SERVICE TIPS

Reference	Subject	Date
PB-131	Door Lock Bitrons	1/11/2021
Product	All 55 Pound and Smaller Girbau Built Washers (Excluding EH055)

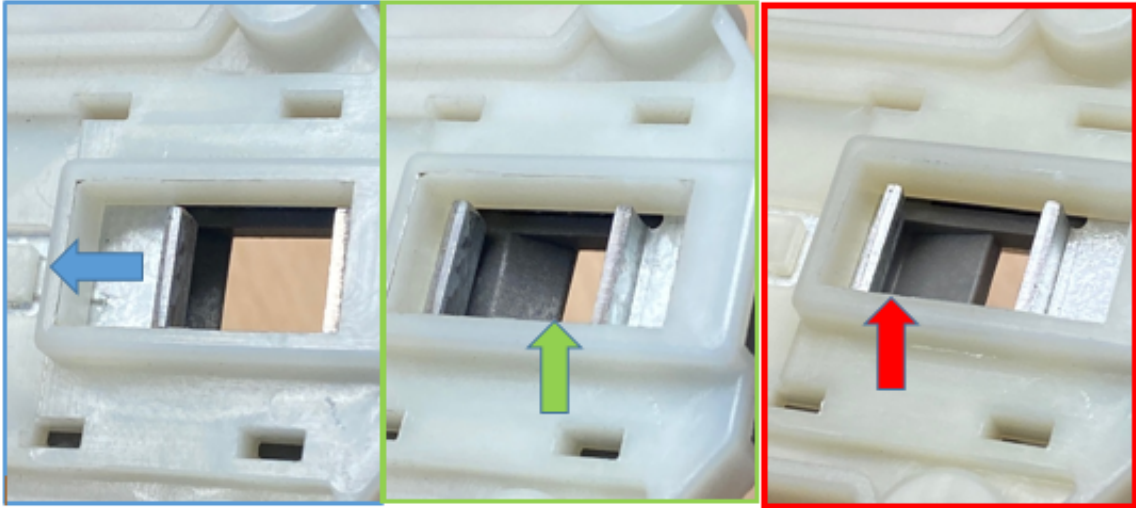
Summary	In 2020, Girbau Spain may have received incorrect door lock assemblies from our supplier, Bitron. The quantities, suspect parts, and dates are unknown. Incorrect Bitron door locks may have been introduced into production machines or service parts. This can cause issues with the door not locking, door not unlocking, and having to push at 10:00 on the door to open it. To inspect the Bitron, slide the locking tab to the side (blue arrow). Look closely at how the catch ramps. The GOOD Bitron (green) slopes towards the opening. The BAD Bitron slopes away from the opening. If you have a customer who has had repeated door lock issues on these units, please inspect the Bitron for the proper catch ramp slope. Please follow the typical warranty process.		
Model Information	 Manually slide and hold metal locking tab to the locked position Inspect Gray Plastic Slope Profile. Slope down toward the opening is GOOD Inspect Gray Plastic Slope Profile. Slope down and away from opening is BAD
